**Champlain Hudson Power Express ("CHPE")
Environmental Management & Construction Plan
Notice of Major Change**

Project: Champlain Hudson Power Express

Notice Number: 084

Location (Milepost, Town/County): Certified Route MP 198.7 to 199.1, Town of Bethlehem, Albany County, New York

G-008

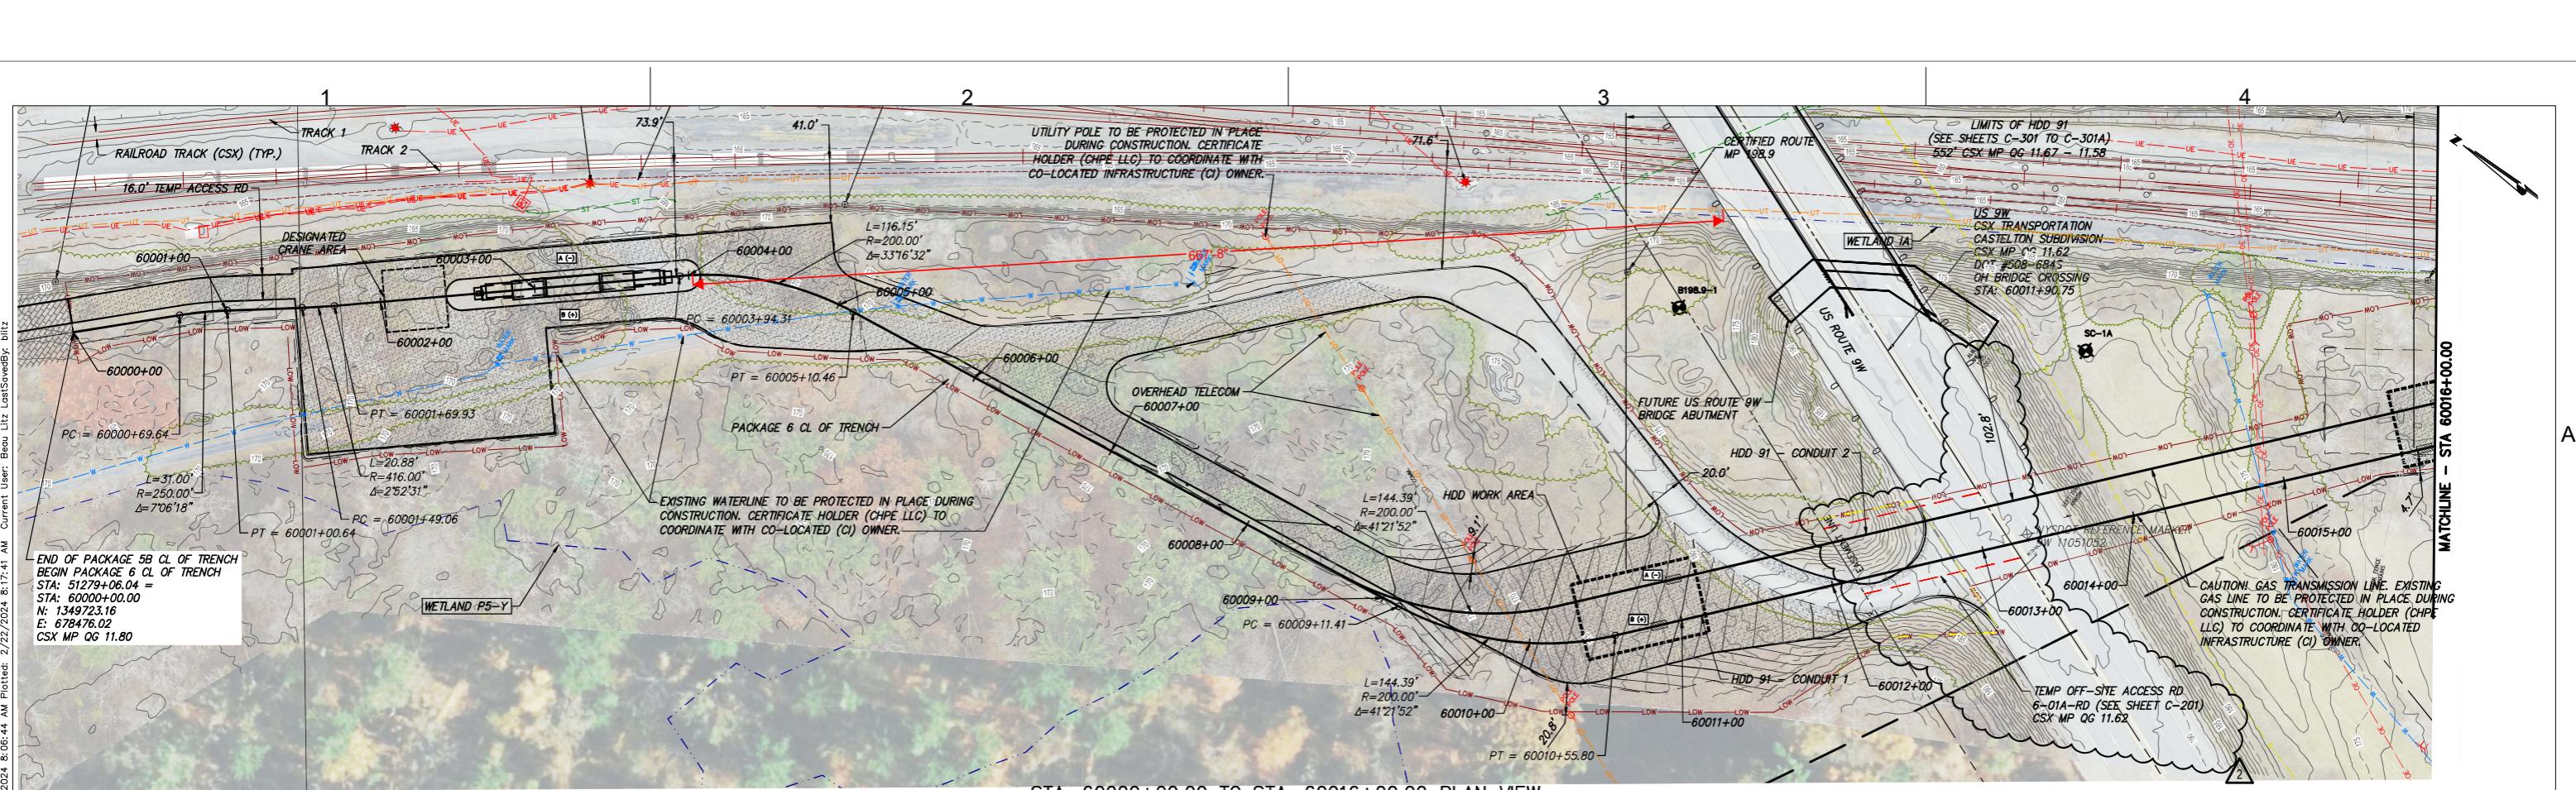
No.	DATE	SUBMITTAL / REVISION DESCRIPTION	DB	APP
1	02/13/2024	NDC-0054: HDD 91 REALIGNMENT FOR NEW RTE 9W BRIDGE	NP	GB
0	02/02/2024	NDC-0066: ISSUED FOR CONSTRUCTION SUBMISSION	WJ	GB

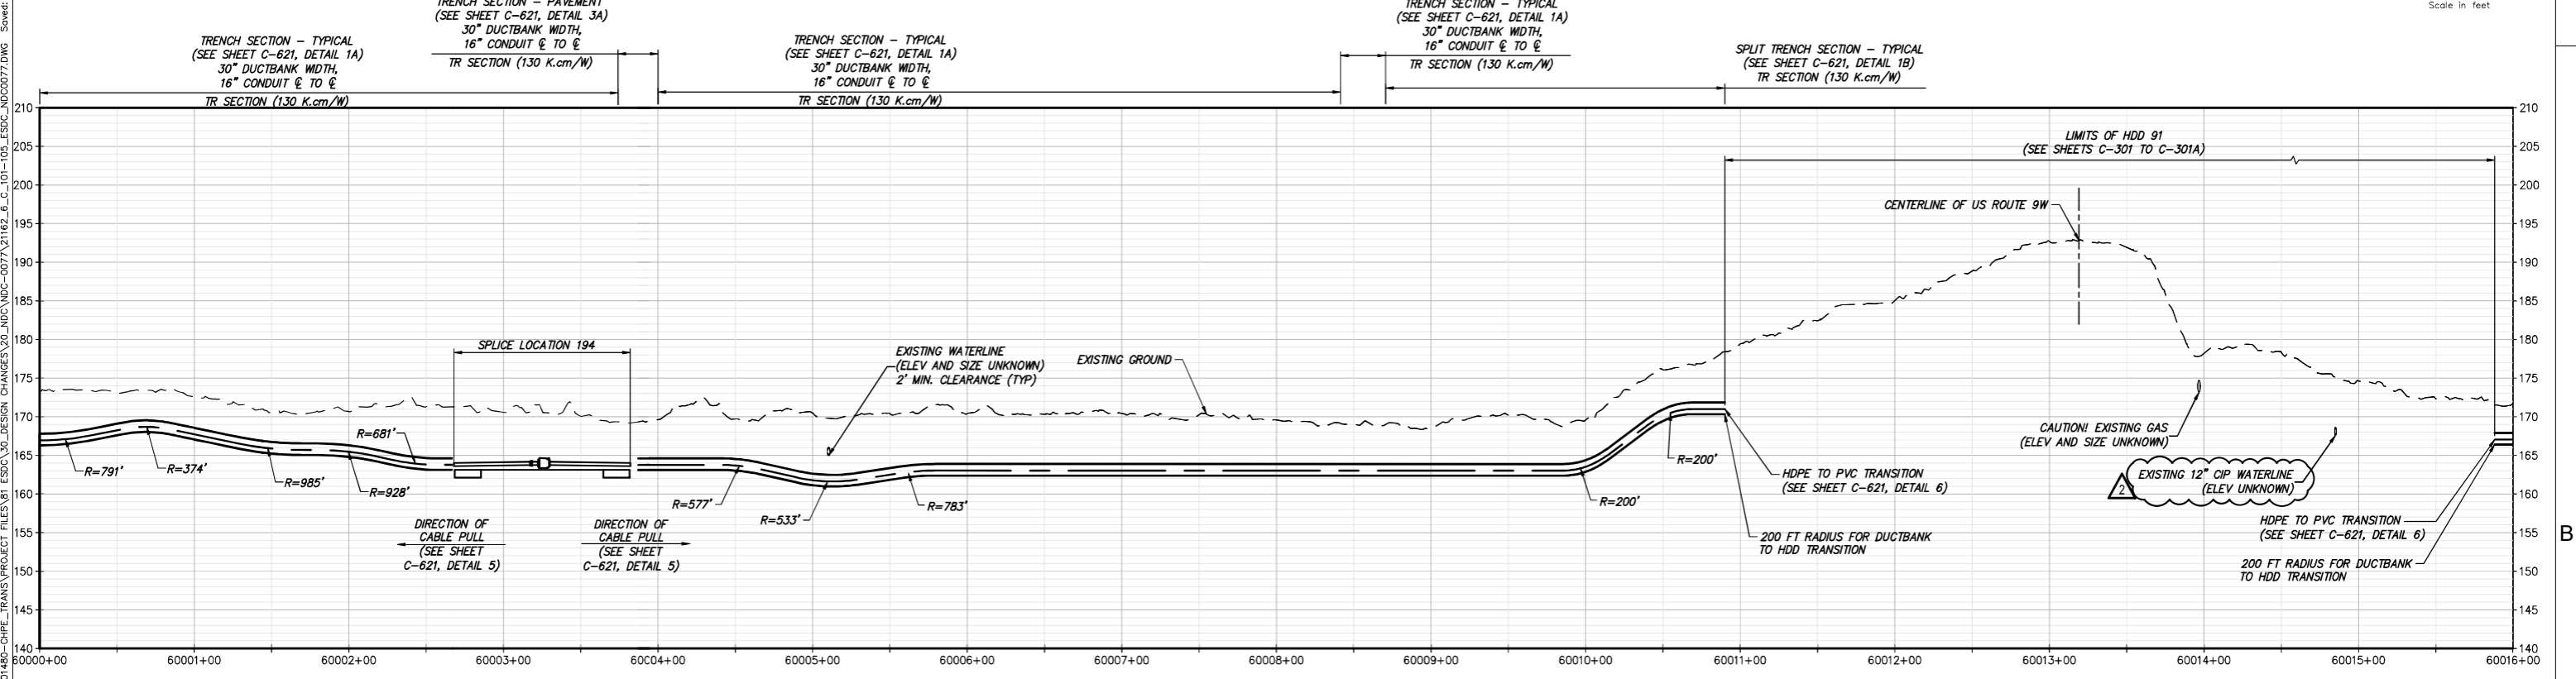
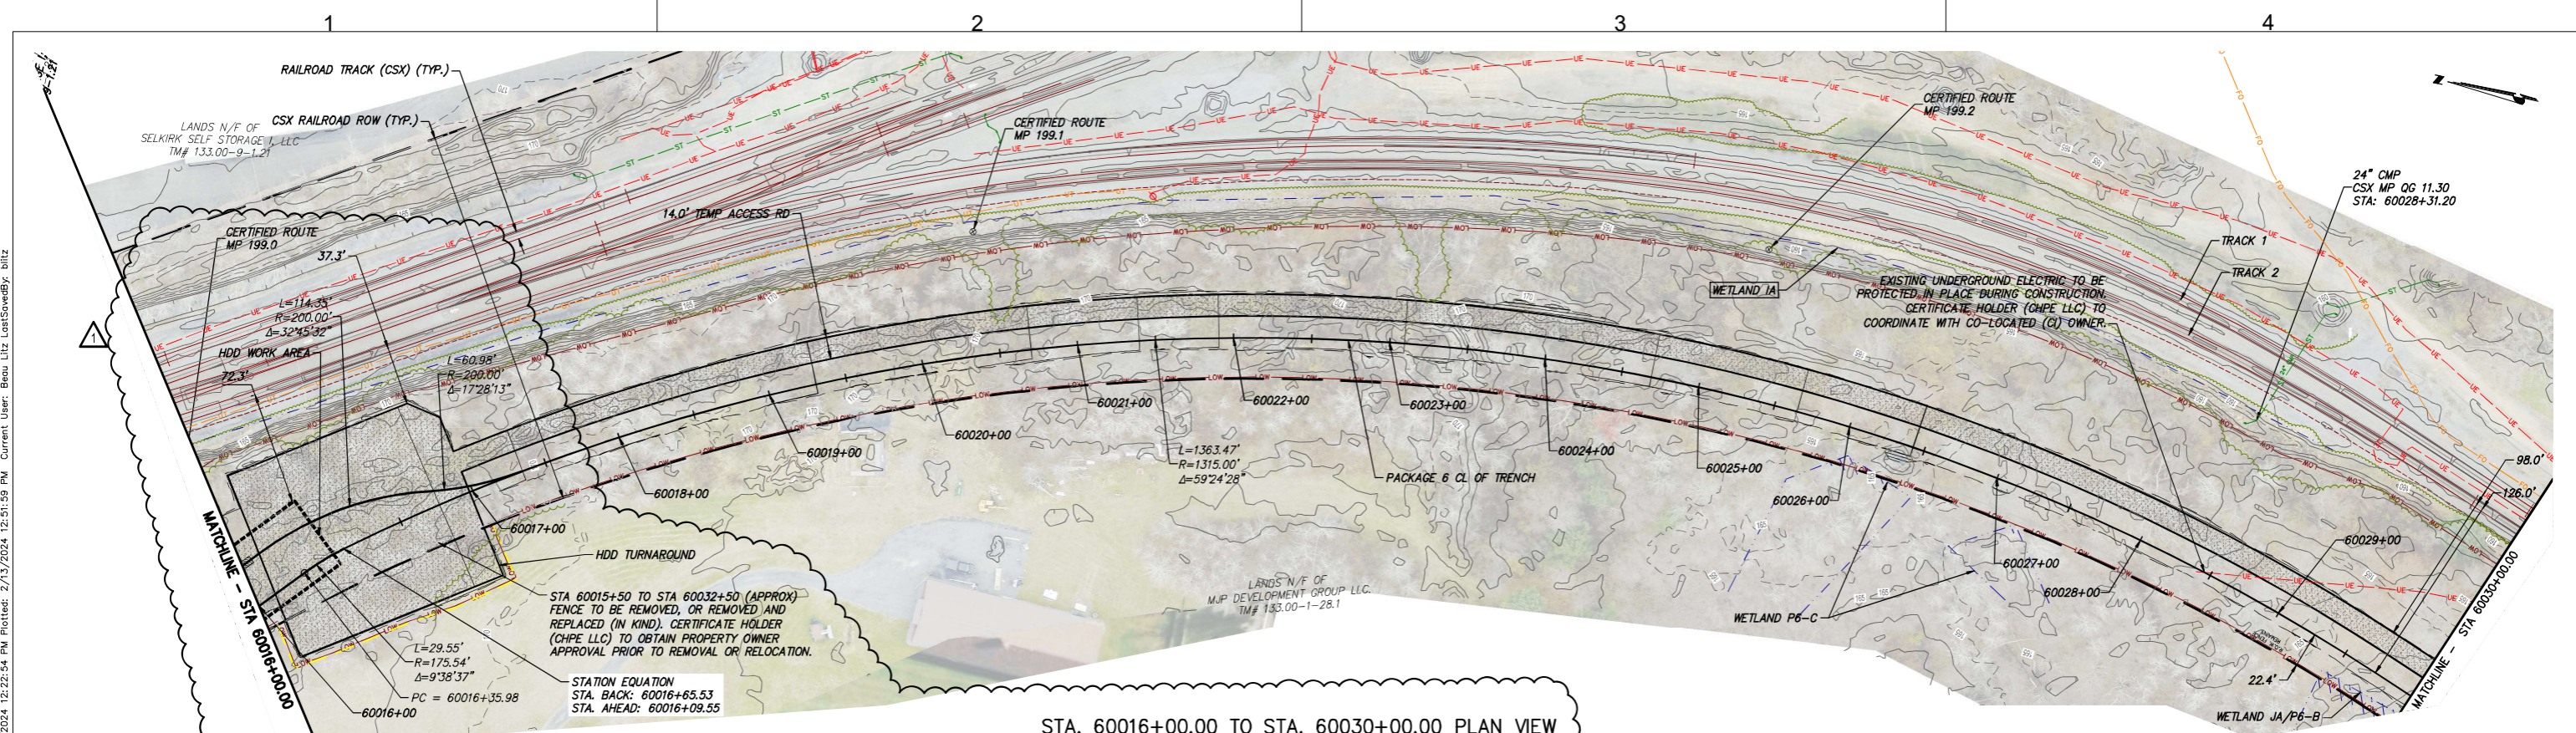
Excursion S10-A is located within the Town of Bethlehem beginning about 670' NW of US Route 9W Crossing of CSX tracks (approximately STA 60004 to 60017 on Sheet C-101 and C-102 of the Plan and Profile Drawings [Appendix C of the EM&CP]).

<table><tr> <th>No.</th> <th>DATE</th> <th>SUBMITTAL / REVISION DESCRIPTION</th> <th>DB</th> <th>APP</th> </tr><tr> <td>1</td> <td>02/13/2024</td> <td>NDC-0054_HDD 91 REALIGNMENT FOR NEW RTE 9W BRIDGE</td> <td>BL</td> <td>RJ</td> </tr></table>

PERMIT DRAWING NO. _____
 DRAWING NO. **C-102**
 19

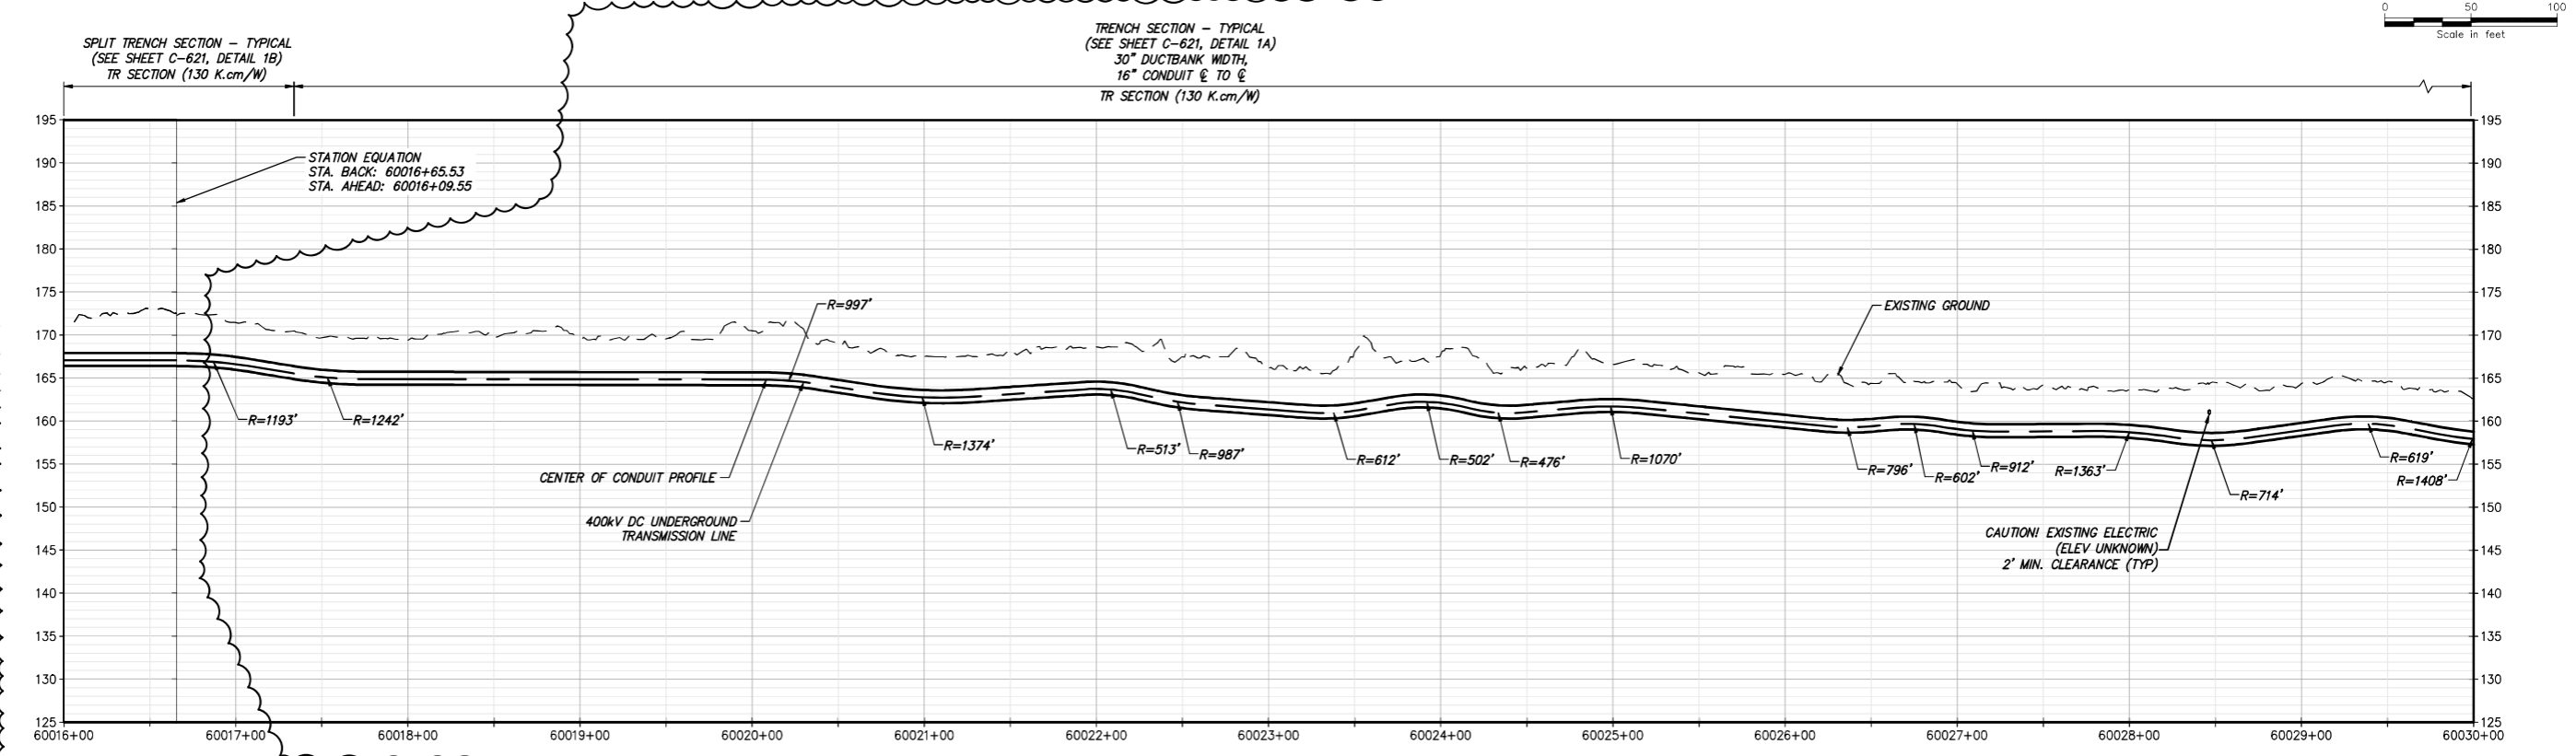
No.	DATE	SUBMITTAL / REVISION DESCRIPTION	DB	APP
1	02/13/2024	NDC-0054_HDD 91 REALIGNMENT FOR NEW RTE 9W BRIDGE	BL	RJ
0	09/29/2023	ISSUED FOR CONSTRUCTION SUBMISSION	BV	TK

DRAWING NO.
C-201

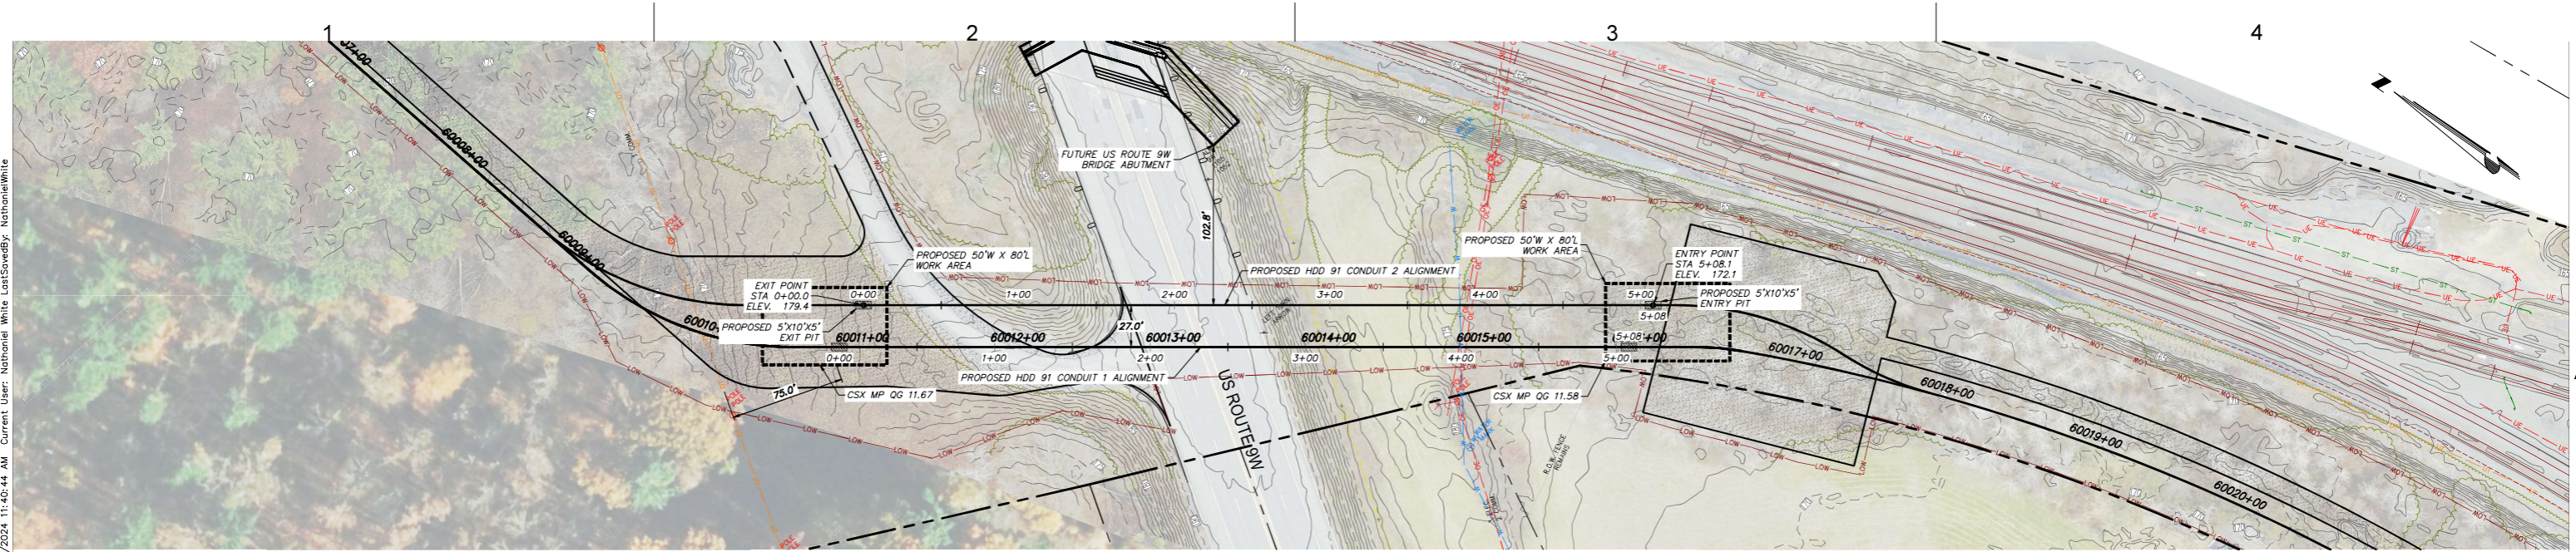
No.	DATE	SUBMITTAL / REVISION DESCRIPTION	DB	APP
1	02/13/2024	NDC-0054: HDD 91 REALIGNMENT FOR NEW RTE 9W BRIDGE	JR	BD
0	09/29/2023	ISSUED FOR CONSTRUCTION SUBMISSION	BV	TK
